ADDENDUM NO. 1

Date:	30 April 2025
Project Name:	ADH Parallel Taxiway B
Owner:	Ada Regional Airport
Garver Project No.	2402254

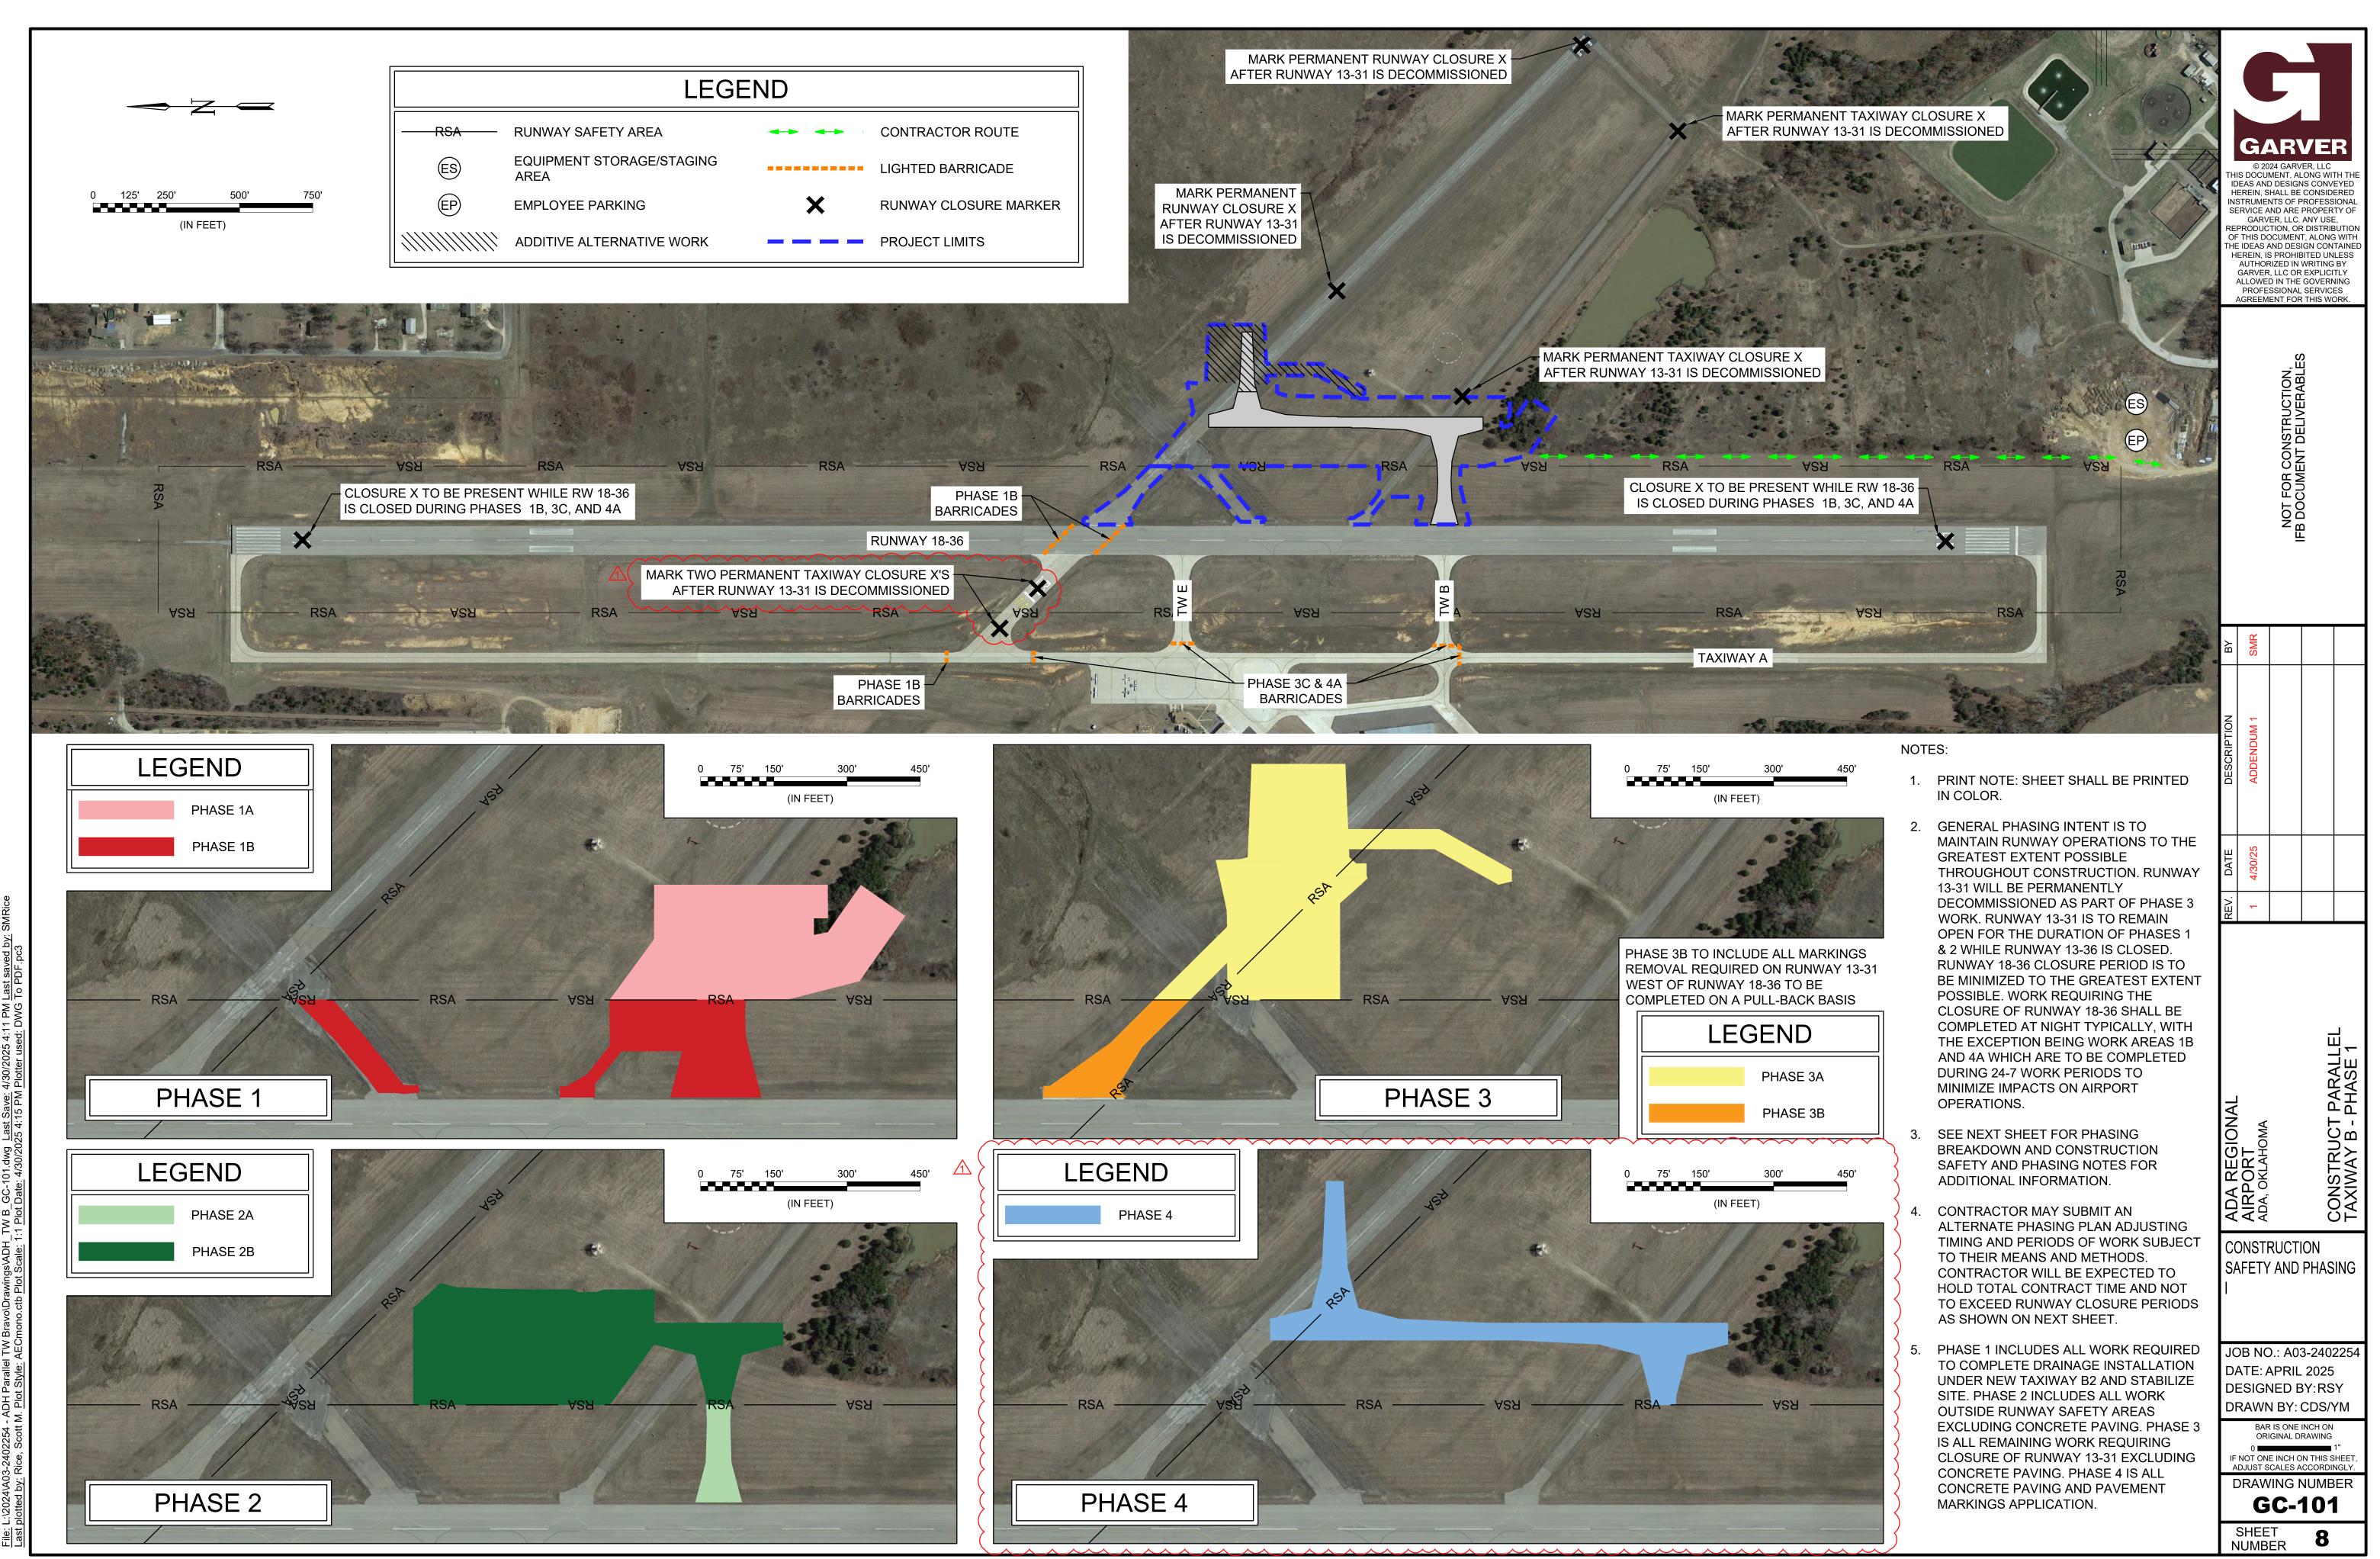
- 3. Plan Sheet CC-101 and CC-102 callouts show different total quantities of pipe and structures than summary of quantities and bid schedule.

- a. GI-002 and Bid Schedule have been updated with the following changes to reconcile these differences: Added a line item for 36" RCP to base bid; Updated alternate bid ODOT manhole quantity from two (2) to one (1); Added a line item for 7'x7' standard grate inlet to alternate bid.

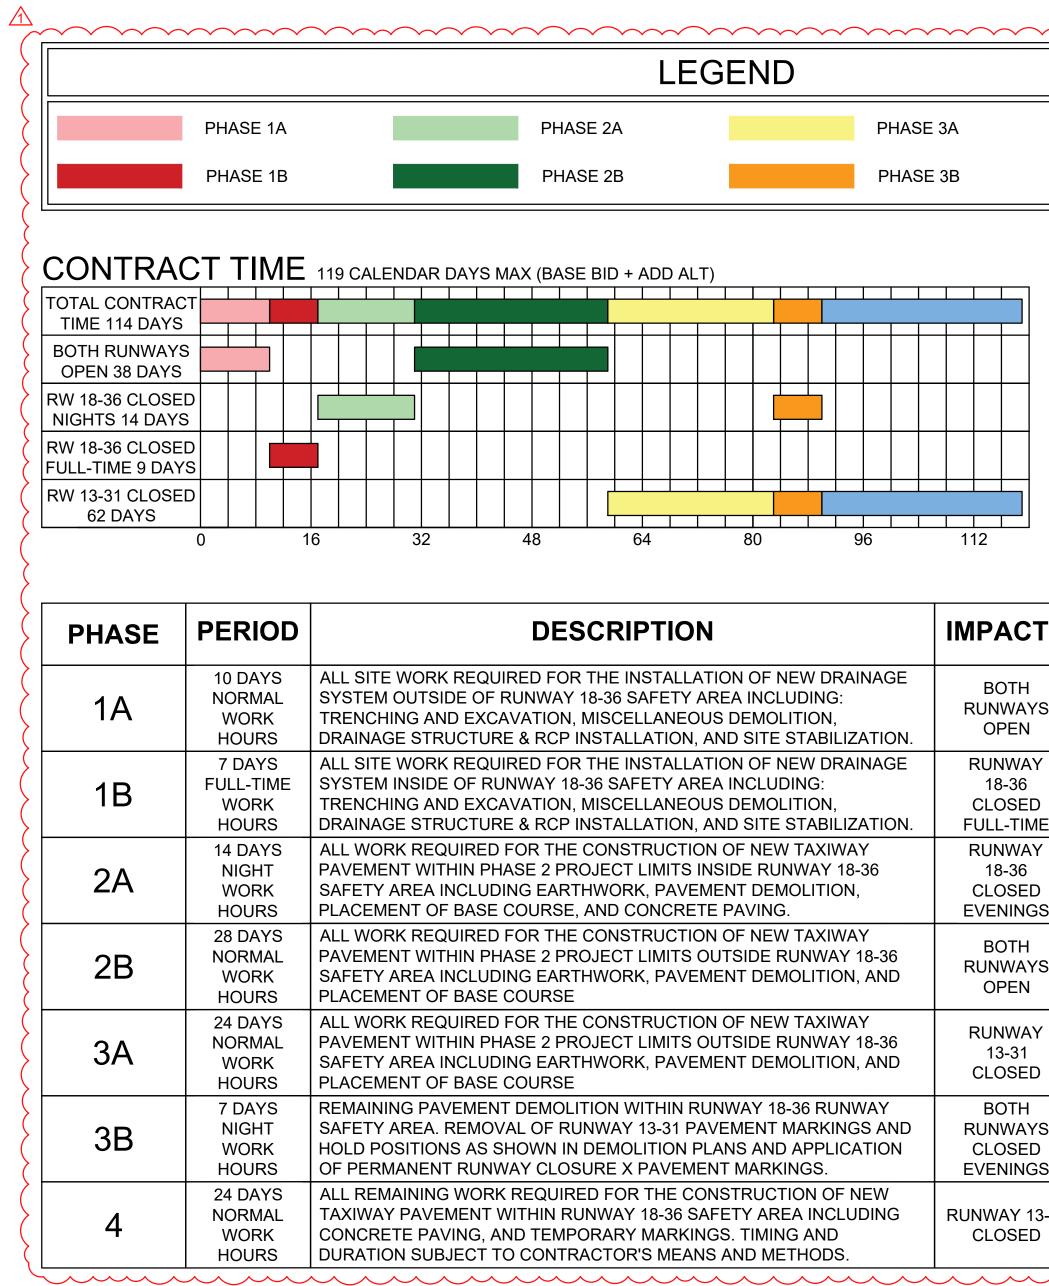
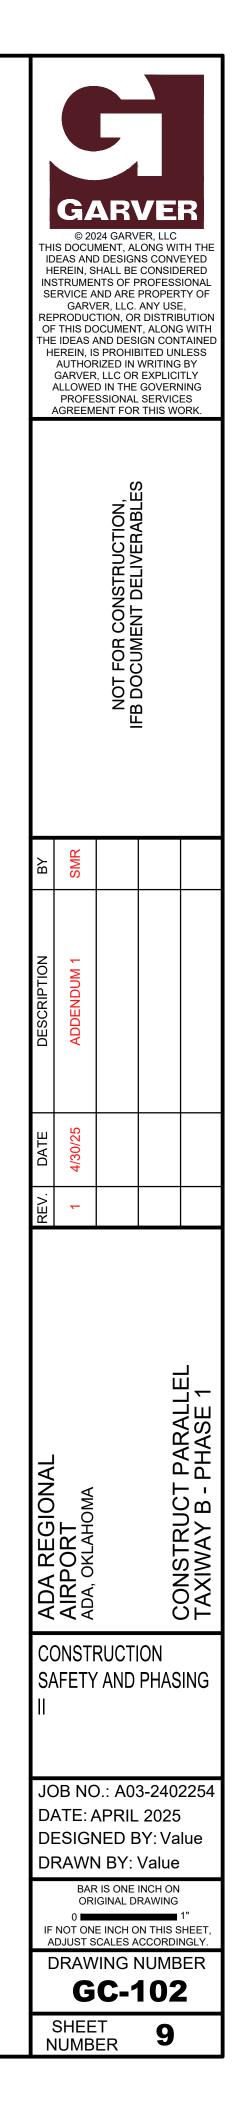
- 6. Are taxiway closure X's needed for the south end of decommissioned Runway 13-31?
 - a. See revised phasing and marking plans sheet GC-101. Taxiway Closure X's added to decommissioned runway end and pavement marking quantities adjusted to incorporate this change.

- 7. How flexible are phasing plan and phase durations depicted in plans? We have concerns about durations and periods of work impacting runway.
 - a. Period of closure of Runway 18-36 from a single 7-day closure to two closure periods one 7day and another 14-day. One 7-day closure for drainage, buried utilities, and trenching, and a second 14-day closure for paving work within Runway Safety Area (RSA). Runway 13-31 to remain open during both of these closure periods. See attached updated project phasing plans.

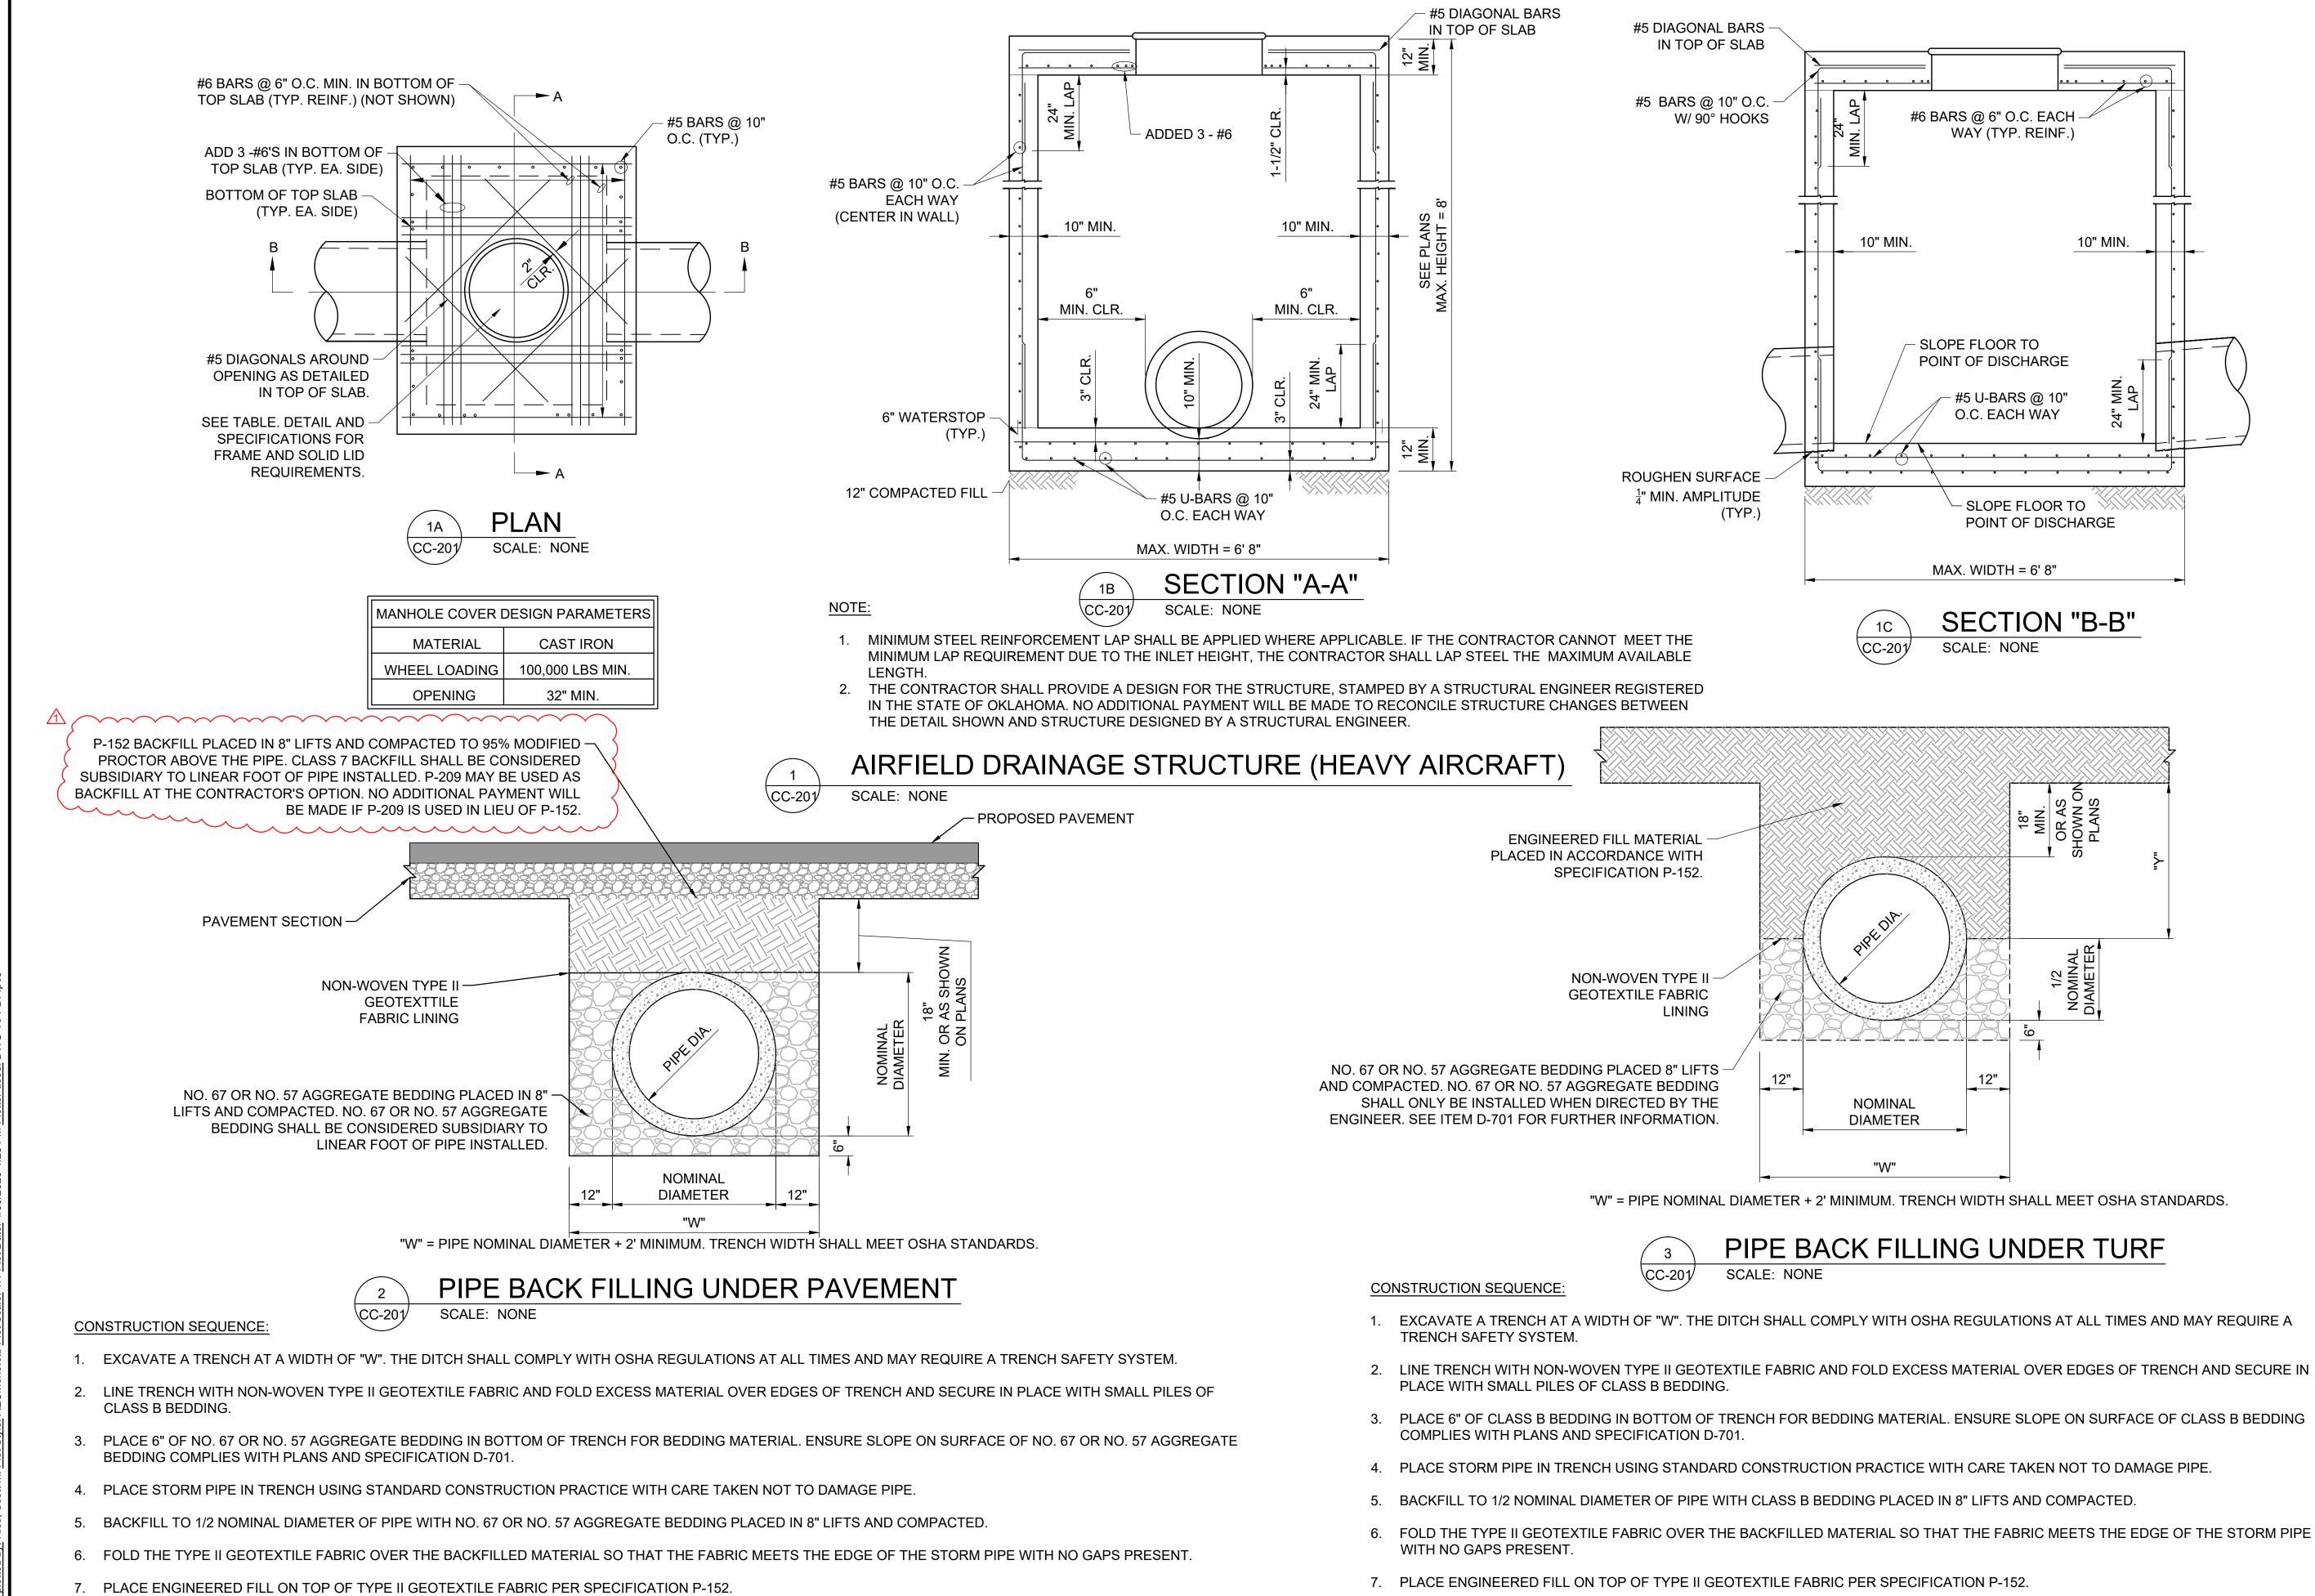
- 14. There are specs for mulching and seeding, however there is not a line item for hydroseeding, is this project sod only?
 - a. Yes
- 15. RCP Backfilling under pavement crossing Typically it is required to be backfill with aggregate to the top of finished subgrade a foot or so outside the pavement edge, detail 2 on sheet 20 depicts dirt being used. Please clarify

- a. Detail 2 Sheet 20 has been corrected see note on detail: "... P-209 may be used as backfill at the contractor's option. No additional payment will be made if P-209 is used in lieu of Class 7."
